JULY 30, 2025

CONTRACT NO. 1800

WET WEATHER PUMP STATION

ADDENDUM NO. 6

430-A-20
ELEVATOR SECTIONS AND DETAILS

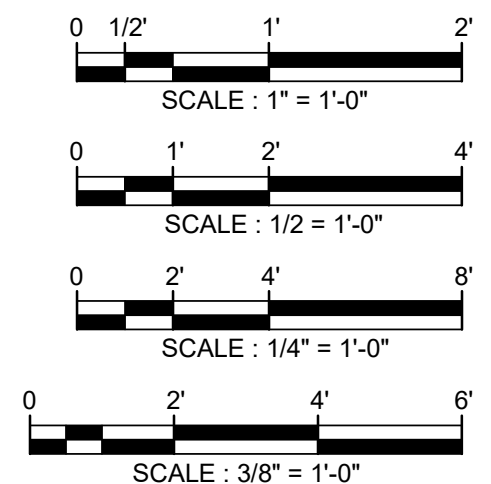
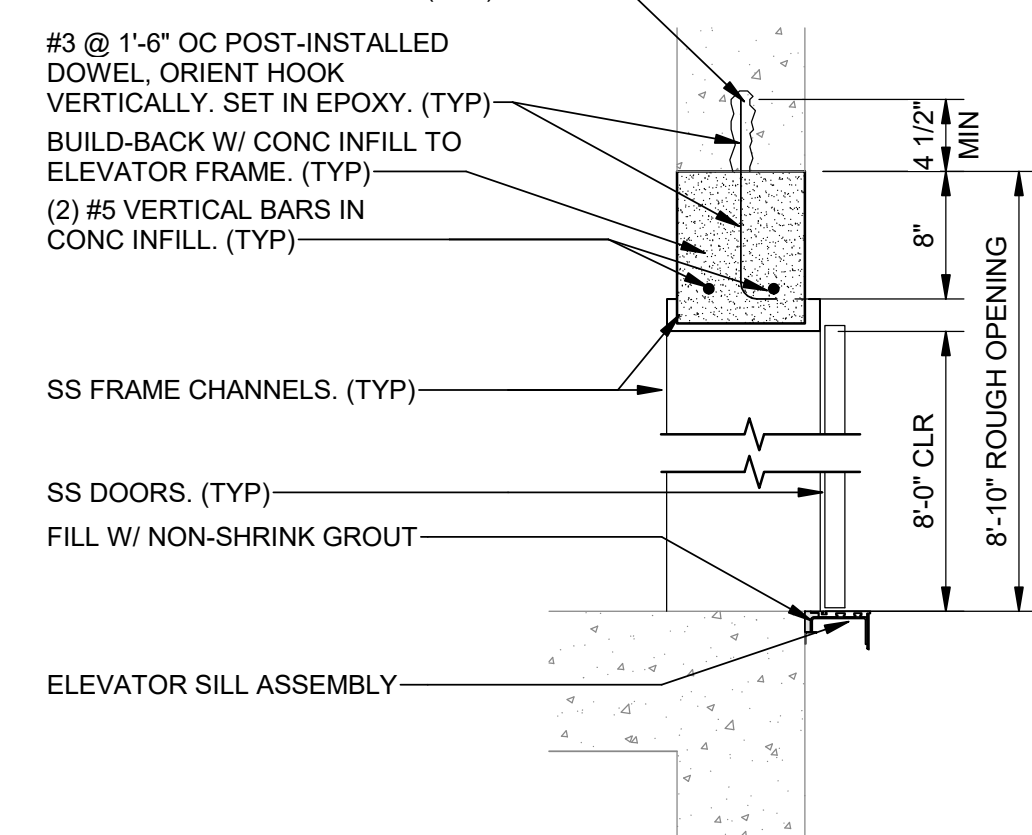
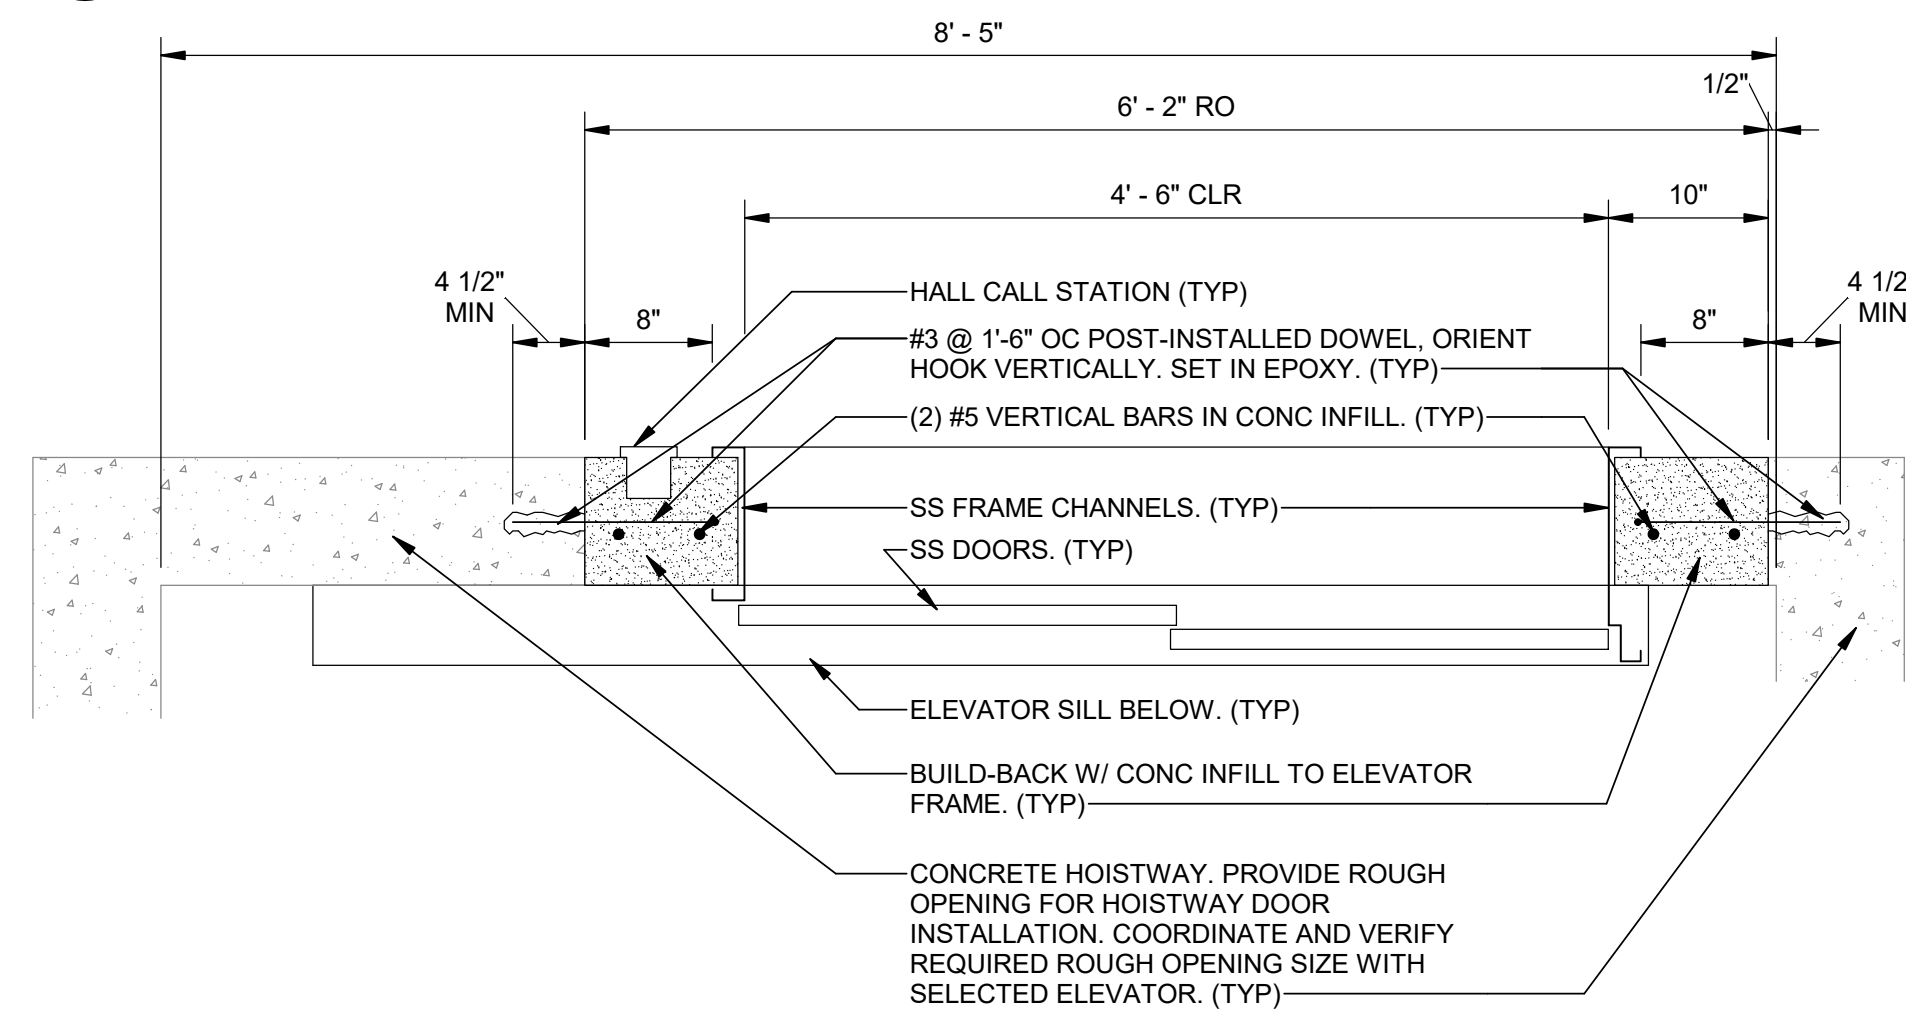
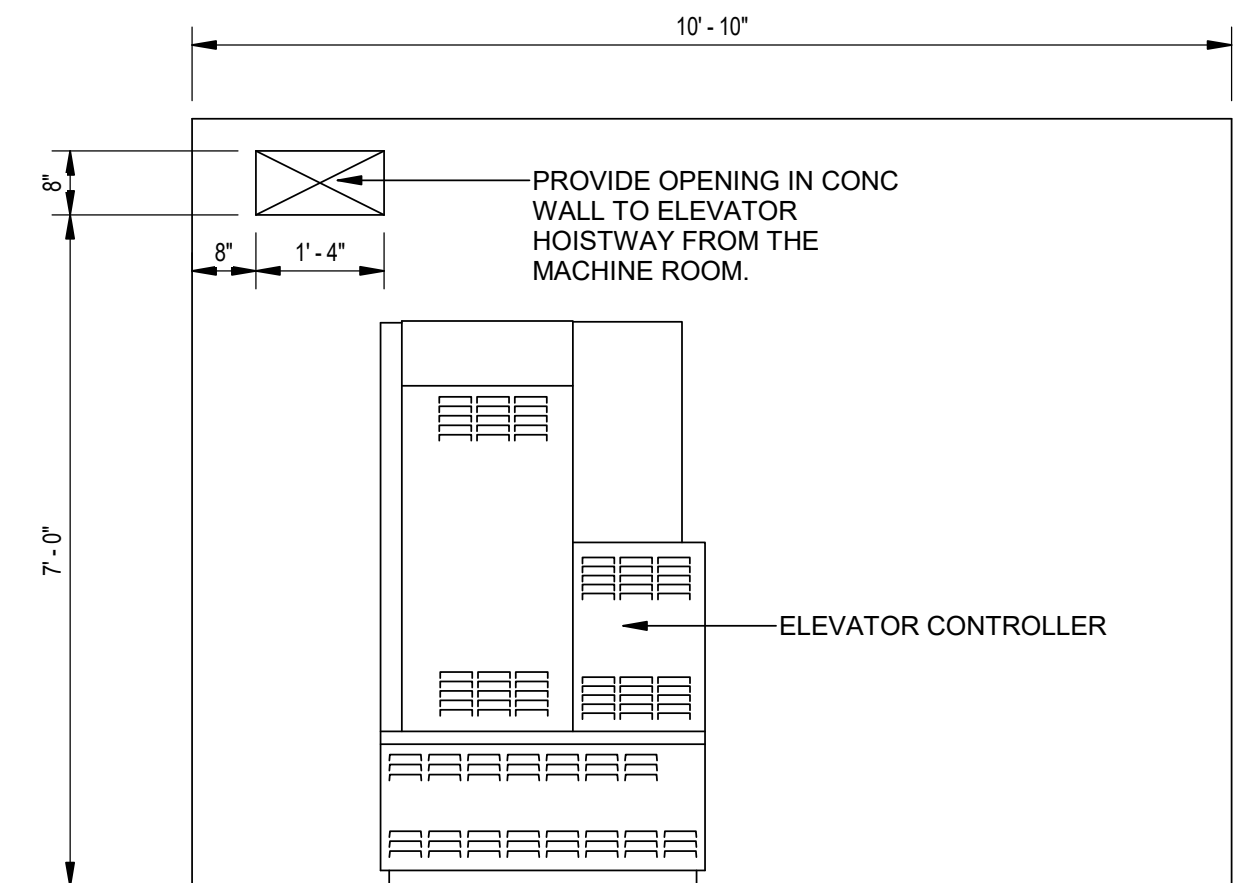
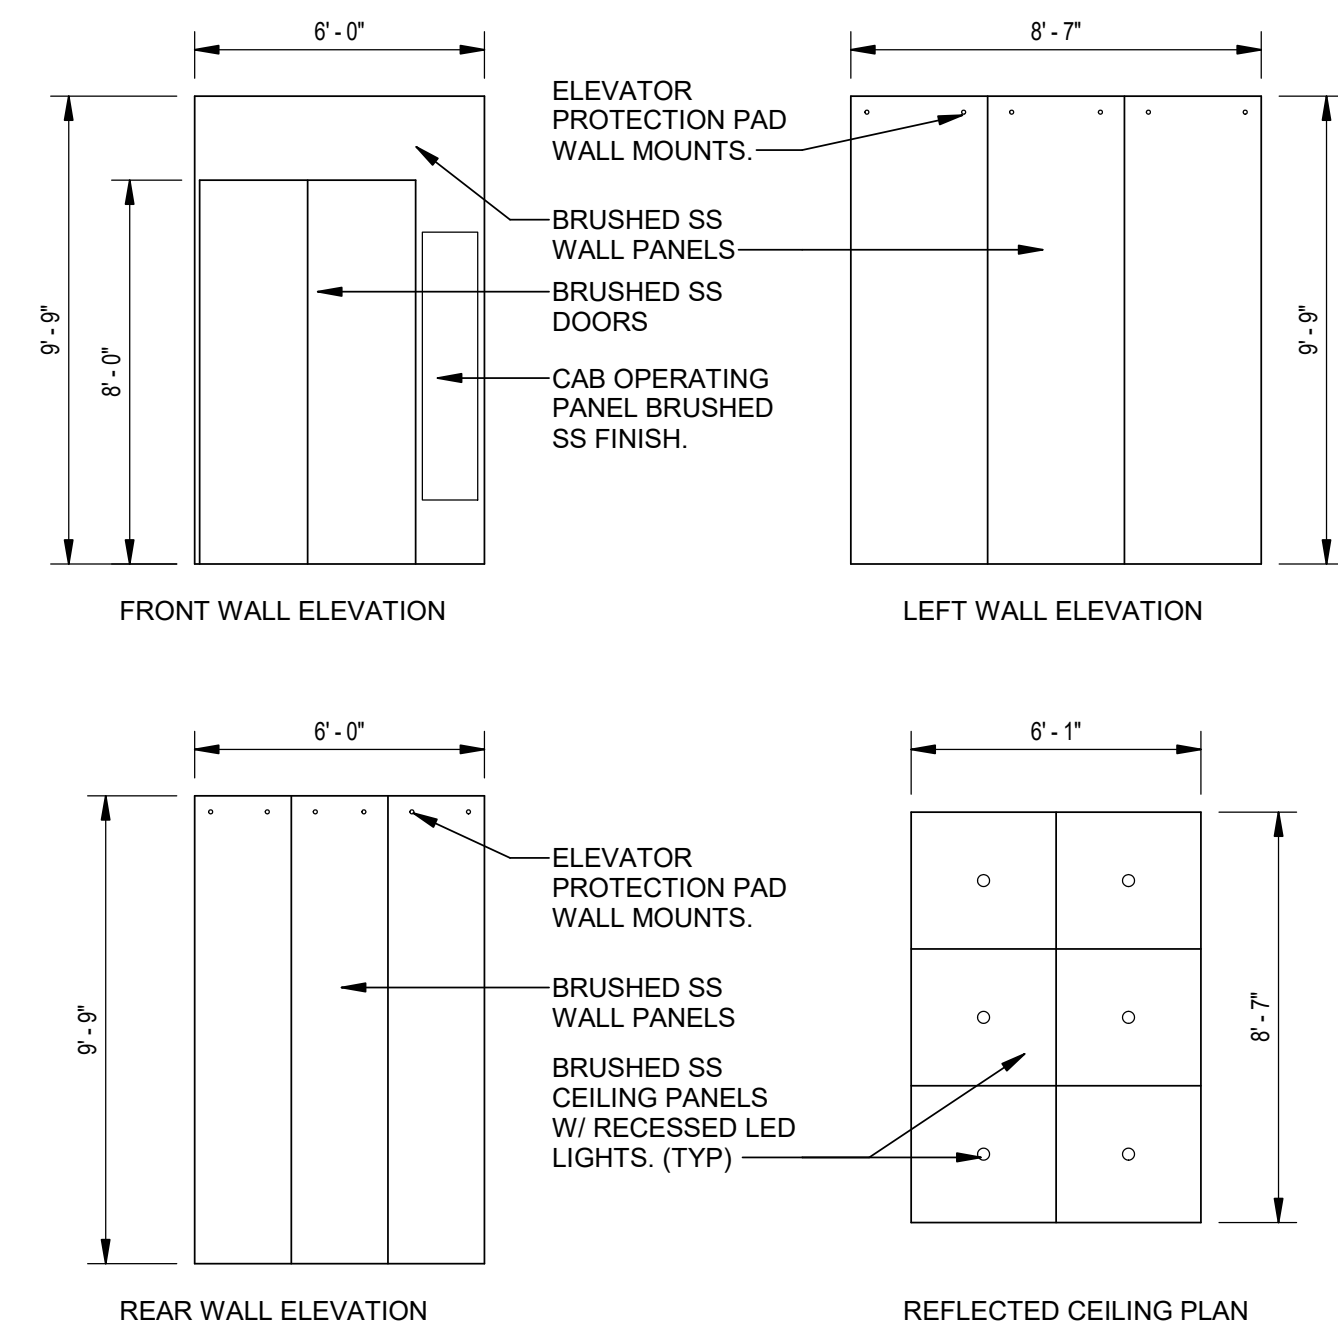
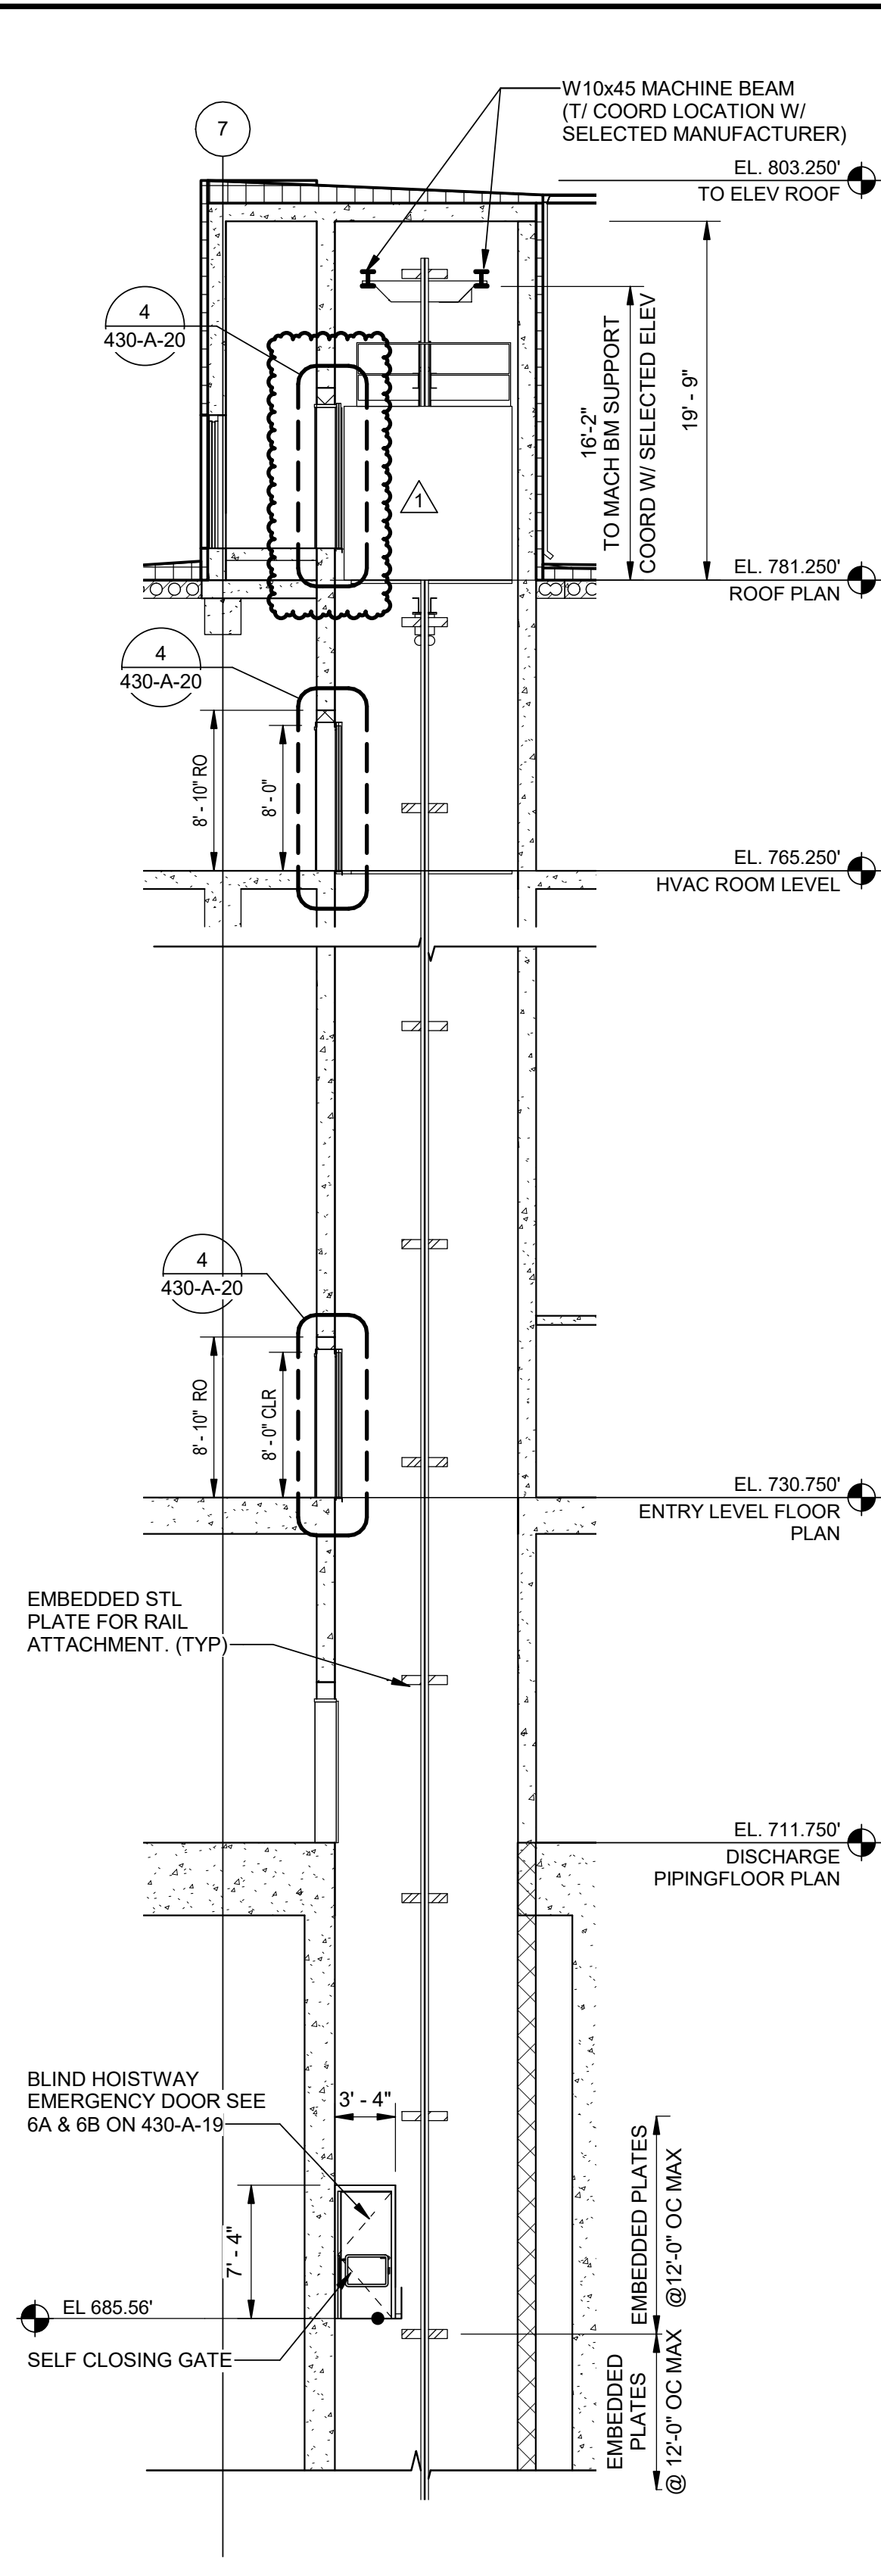
- 4.1 **REPLACE** Sheets 430-S-47 and 430-S-48 with Sheet 430-S-47 Rev. 01 and 430-S-48 Rev. 01, refer to Attachment C.
- 4.2 **REPLACE** Sheets 430-A-09, 430-A-20, 430-A-28, 430-AS-01, and 430-AD-09 with Sheets 430-A-09 Rev. 01, 430-A-20 Rev. 01, 430-A-28 Rev. 01, 430-AS-01 Rev. 01, and 430-AD-09 Rev. 01, refer to Attachment C.

- A62:** Refer to Section 01 11 00.
- Q63:** Reference detail 1B on drawing 430-A-20 Elevator Section-Continuation, specifically the elevator opening on the roof plan elevation. The bottom of the elevator door opens at the roof plan elevation, but there is a step directly in front of this opening obstructing the elevator opening. Please provide a revised detail to allow for elevator egress.
